Access Compliance Report

Public Rights-of-Way

Intersection ID: 18797	Main Street: SENECA_PL	Cross Street: WEDGEWOOD_DR	Location: SW
ADA ID: FA32075573D7	Ramp Type: BlendTrans1	Initial Pass/Fail: Fail	Overall Compliance: No
Severity Score: 12.5			
Codes/Mitigation Info/Possible Solution		Field Measurements/Component Compliance

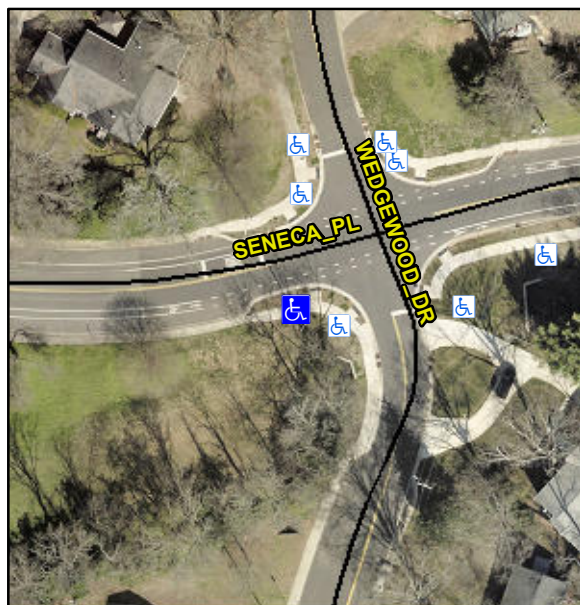
Not Found, R304.5.3

Compliance	Description	Data	Compliance	Description	Data
N/A	Ramp Length (in)	83.0	Yes	BlendTrans Slope (%)	2.7
Yes	Ramp Width (in)	72.0	No	BlendTrans XSlope (%)	6.5
N/A	Flare Type LT	N/A	N/A	Flare Type RT	N/A
N/A	Flare Slope LT (%)	N/A	N/A	Flare Slope RT (%)	N/A
N/A	Flare Traversable LT?	N/A	N/A	Flare Traversable RT?	N/A
N/A	Landing Length (in)	N/A	N/A	DWS Provided?	N/A
N/A	Landing Width (in)	N/A	N/A	DWS Contrast?	N/A
N/A	Landing Slope (%)	N/A	N/A	DWS Length (in)	N/A
N/A	Landing X Slope (%)	N/A	N/A	DWS Full Width?	N/A
N/A	Landing Curb? (Y/N)	N/A	N/A	DWS Offset (in)	N/A
N/A	Shared Landing?	N/A			
N/A	Gutter Ponding?	N/A	N/A	Gutter Slope (%)	N/A
N/A	Gutter Lip Ht (in)	N/A	N/A	Gutter X Slope (%)	N/A
N/A	Painted X Walk1?	No	N/A	Painted X Walk2?	N/A
	X Walk 1 Direction	To N		X Walk 2 Direction	N/A
	X Walk 1 Width (in)	N/A		X Walk 2 Width (in)	N/A
	X Walk 1 Slope (%)	6.5		X Walk 2 Slope (%)	N/A
	X Walk 1 X Slope (%)	5.6		X Walk 2 X Slope (%)	N/A

N/A	Ramp inside XWalk1?	N/A	N/A	Ramp inside XWalk2?	N/A
	Road Slope (%)	5.6		Clear Space?	N/A
	Road X Slope (%)	6.5	N/A	Clear Space to XWalk (in)	N/A
N/A	Any Obstructions?	N/A	N/A	Storm Grate/Utility Hazard?	N/A
	Obstruction Type			Storm Grate/Utility Type	
		N/A			N/A
			Yes	Surface Condition? (G/P)	Good
			No	Curb Slope (%)	6.2

Remove & Replace Curb Ramp With Two New Directional Ramps or Equivalent.
